Installation Addendum
Dodge Ram 03-07 PRXB Kit

SUBJECT: Dodge Ram PRXB Kit Compressor Ground Wire Extension

SUBJECT: IDENTIFICATION OF 48RE TRANSMISSION IN 2003 DODGE RAM

SUBJECT: Pyrometer Thermocouple Installation Warning

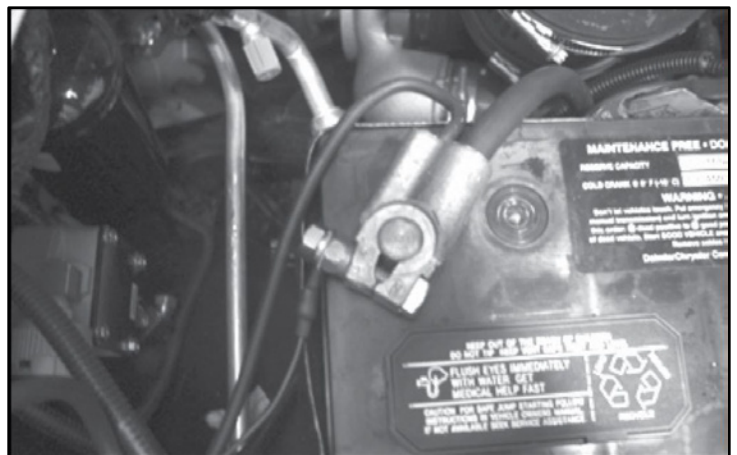
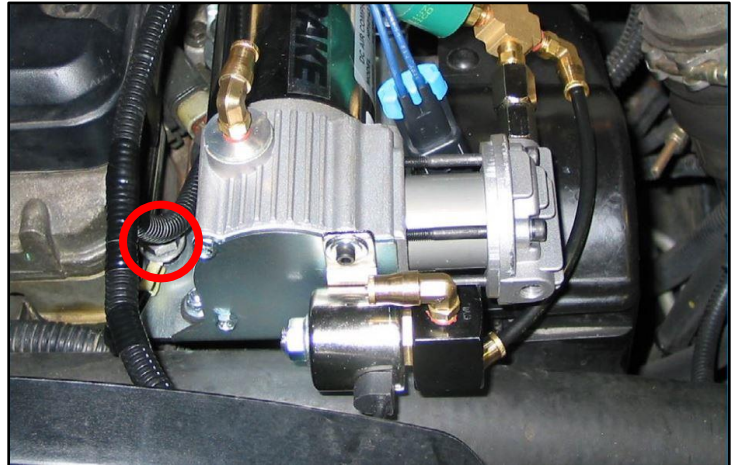
This ground wire extension is to be installed in addition to the short ground wire from the compressor assembly.

1. Locate the bolt securing the compressor assembly ground wire. One ring terminal of the ground wire extension will be installed around this bolt. Remove the bolt.
2. Insert the bolt through one ring terminal of the ground wire extension and the ring terminal of the compressor assembly ground wire. There should be two ring terminals on the bolt, below the washer.
3. Re-install the bolt. Clock the ring terminals as necessary to ensure they sit flat. Torque to 32 ft.-lbs. (43.4 Nm).
4. Route the free end of the ground wire extension along the existing compressor wiring harness to the negative terminal of the battery.
5. Connect the ring terminal to the negative battery terminal.
6. Use the supplied zip ties to secure the wire away from heat sources and moving components.

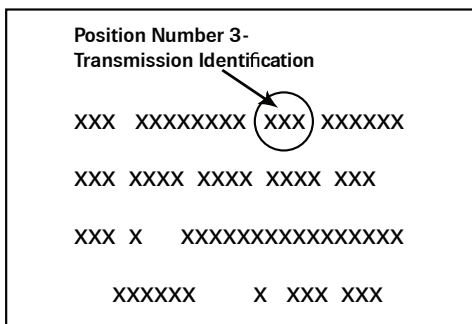
- BODY CODE PLATE** - Check the 3rd position (as shown in the illustration)
DG8 = Model 48RE - 4Speed Automatic | DGP = Model 47RE - 4 Speed Automatic

The Body Code Plate is located behind the headlight on the passenger side. The headlight does not need to be removed to access it. Standing in front of the vehicle, look at the left radiator support brace for the location (as shown in photo by arrow).

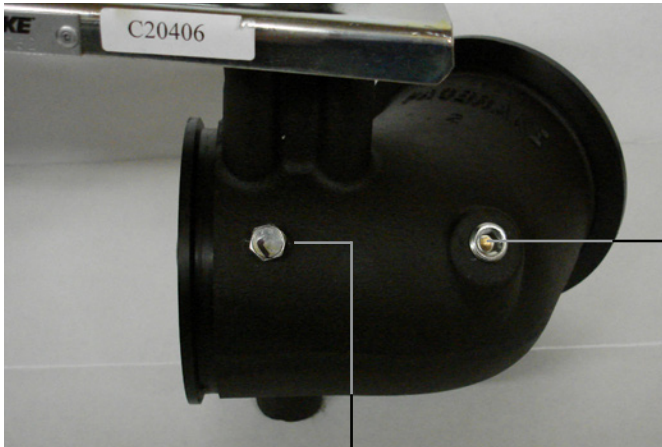
Do not install a pyrometer thermocouple in the back pressure test port, damage to the thermocouple will result.

Pyrometer Thermocouple Port
1/4" NPT

Back Pressure Test Port
1/8" NPT
